**MEMO: CONDITIONAL USE PERMIT (CUP)
FOR LETURNO-HWY 126**

AGENCY FILE NO.: PC 24 01 CUP 01 (PC 23 27 CUP 04)
AGENCY CONTACT: WENDY FARLEYCAMPBELL, AICP,
COMMUNITY DEVELOPMENT DIRECTOR
CITY OF FLORENCE
WENDY.FARLEYCAMPBELL@CI.FLORENCE.OR.US

DATE OF THIS DOCUMENT: 07/24/2024

This narrative addresses March 1, 2024, Notice of Incompleteness (NOIC), June 7, 2024 meeting with Florence planning staff, and city staff comments received prior to the meeting regarding Land Use Application PC 24 01 CUP 01 a request for a Conditional Use Permit to allow the development of 10 attached single unit dwellings, and within the Commercial District as regulated by Florence City Code Title 10, Chapter 15. This site is located at 5439 Hwy 126 as shown on Assessor's Map # 18-12-26-31, Tax Lot 02300.

Map 1 - Snip from attached Utility Plan showing location of proposed Street Light

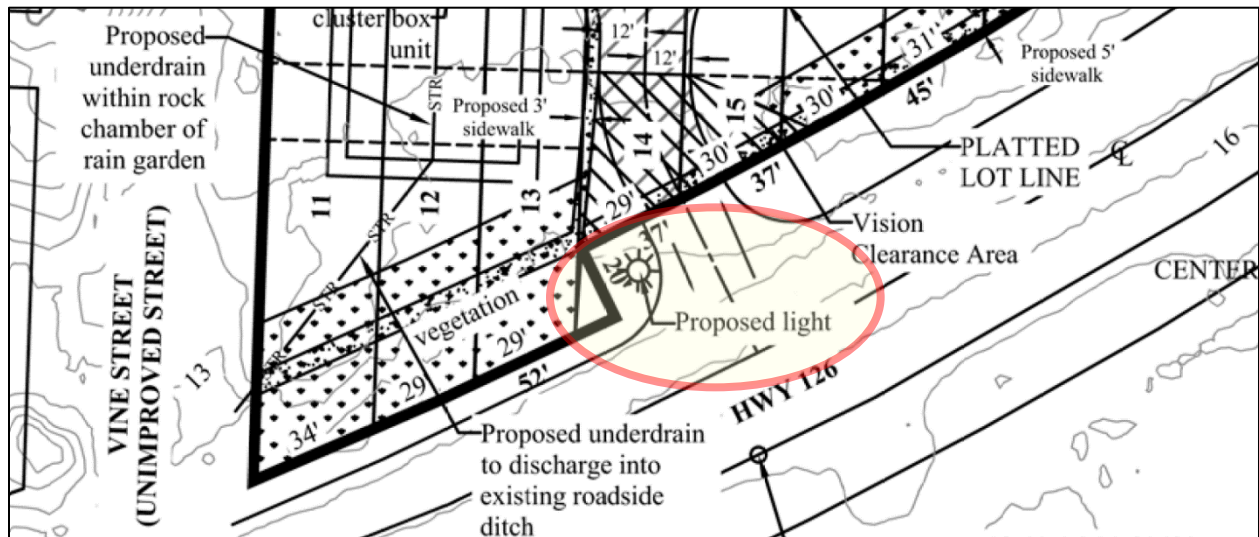
**Street lights are required in all developments within the City for public safety. A street light where the shared driveway intersect the Hwy 126 ROW will be required.**

- **Provide the street light proposed location**

Response: Applicant proposes a streetlight at the entry to the as illustrated in the utility plans. Please see attached plans and snip below.
